CABIN CREEK DAM

NDS ID NO. PA-00336

RED LION MUNICIPAL AUTHORITY
PHASE I INSPECTION REPORT
NATIONAL DAM INSPECTION PROGRAM

PHASE I REPORT
NATIONAL DAM INSPECTION REPORT

Photograph No. 3

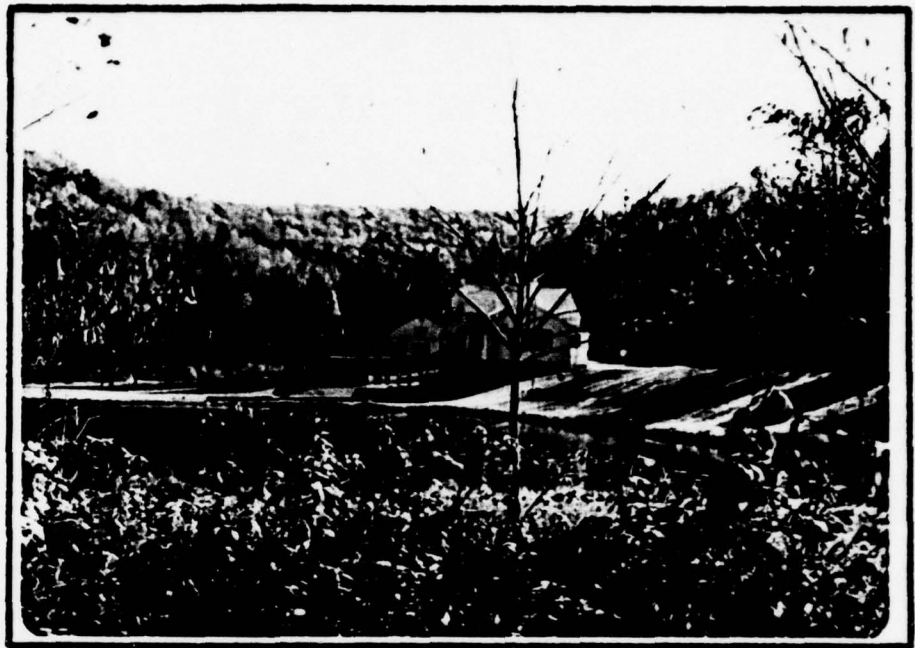
The rock debris in the spillway exit channel has some restricting effect on the capacity of the channel. The trees growing on the exit channel highwall may cause landsliding. Visual observations indicate that the Bascule gate is in good condition. The condition of the water supply line is unknown.

Spillway exit channel, debris in channel and hydraulically controlled spillway.

8. The debris in the emergency spillway exit channel should be removed. Trees on the highwall should be removed.
